Rev	ID
R12	PC104IF UNIVERSAL
Date: 6/21/2019	Page: 1 of 5

ADLink Related Updates:
1. CMOS battery backup connector
2. Right Angle serial comm connectors (BOM only)
3. SATADOM 5V power connector

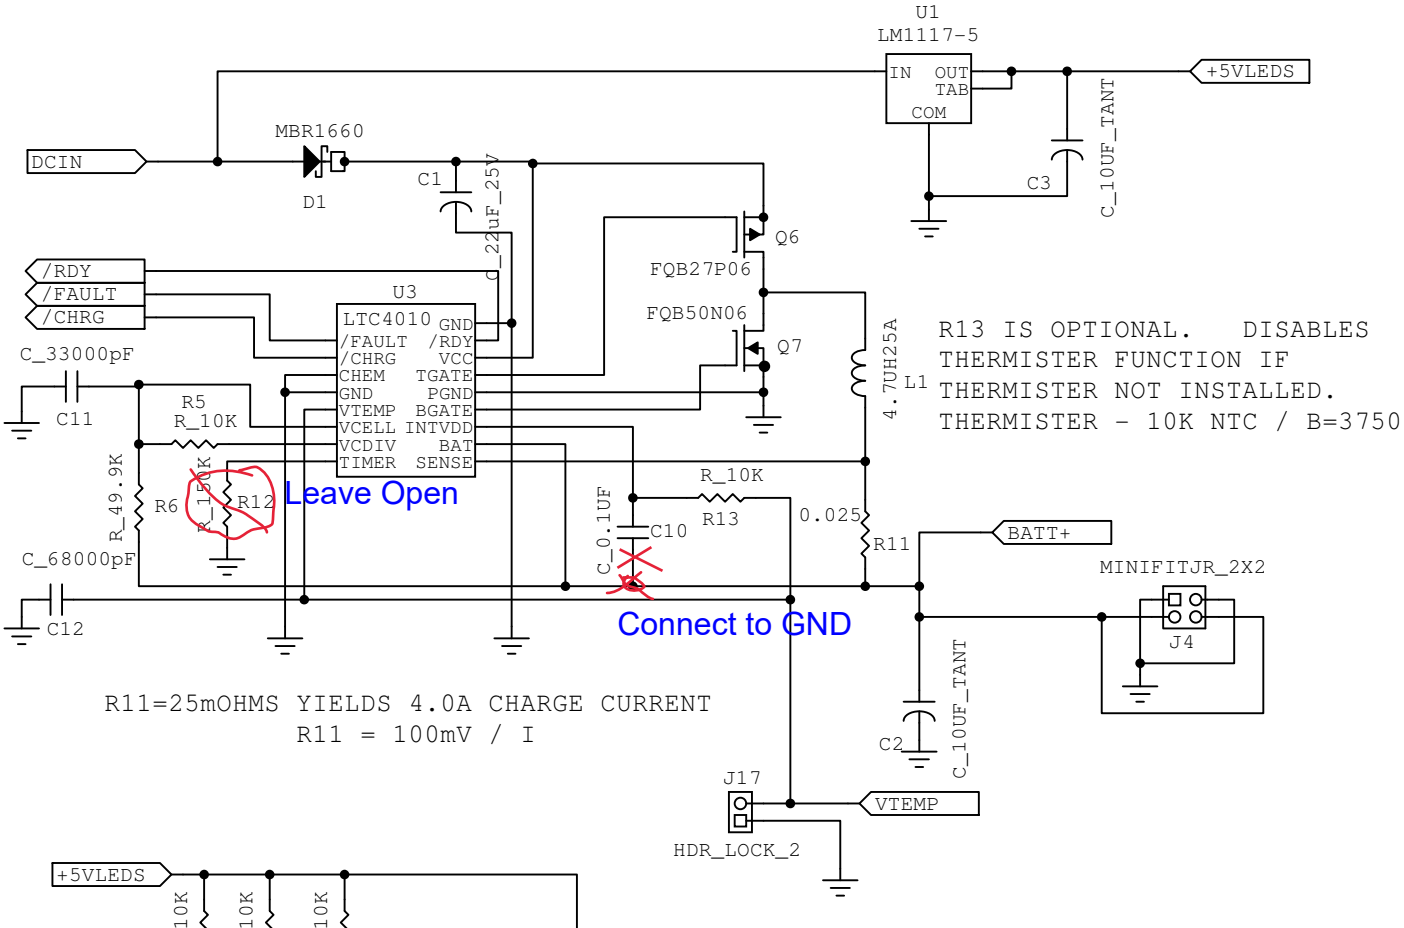
- Input connection moved to
  after the reverse polarity diode D1 (R11 -adb)
WRONG: Battery+ connection is then applied to U1 and
LED stays on indefinitely. Moving connection back to DCIN side (R12 6/21/19 -adb)****

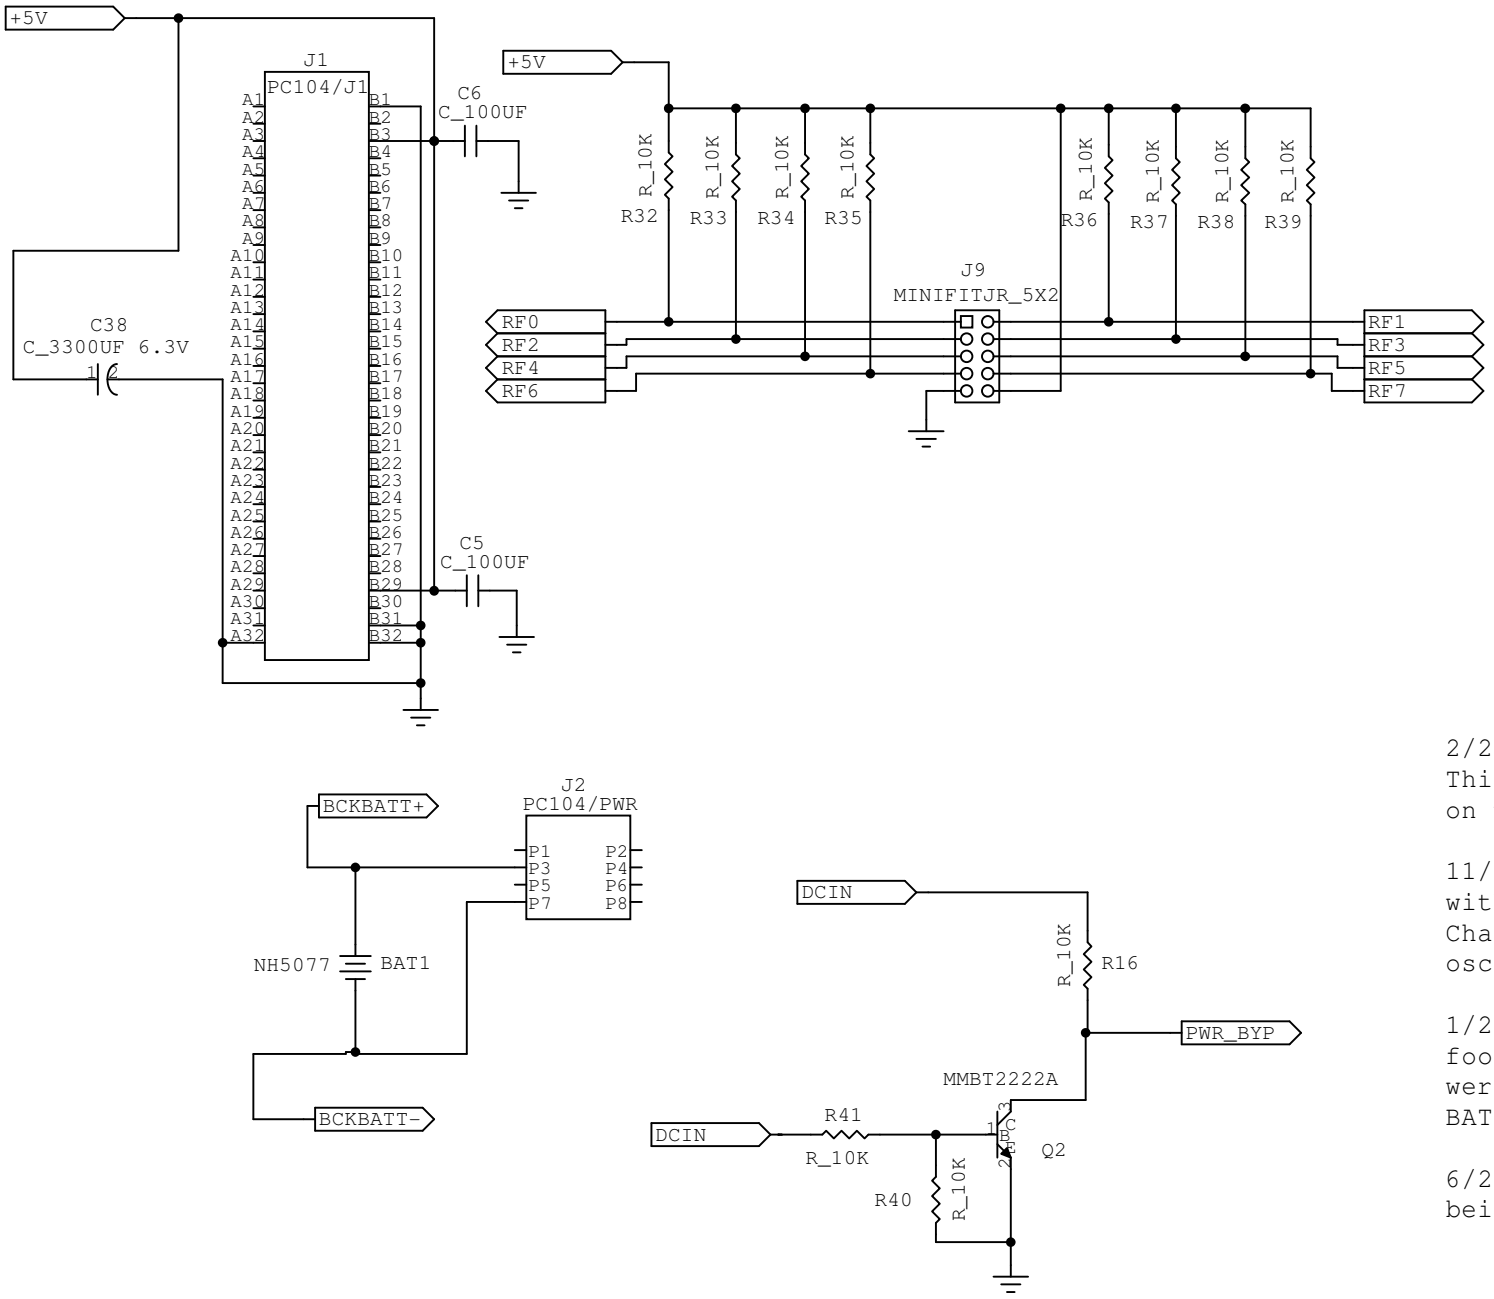
(REV 9): K1 Relay and D3 replaced with NTE2355 PNP Transistor
being done by MFG'g (Will not allow power to be turned
charging via external DC IN)

(REV 10): NTE2355 BJT thru hole component too tall and causes interference
ial cable beneath SBC.
o MMBT2222. Removed Y2, C22, and C23 as PIC being run with internal
or

(REV 11): Reverse polarity protection added to DC_IN. Q2 Component
t corrected in layout for incorrectly mirroring. Removed R14 and R15 which
ng used to preserve signal names when relay was being used. BATTA+ became

(REV 12): Reverse polarity fix applied battery+ to U1 IN resulting in LED
indefinitely. Moved connection back to DCIN side of diode D1.
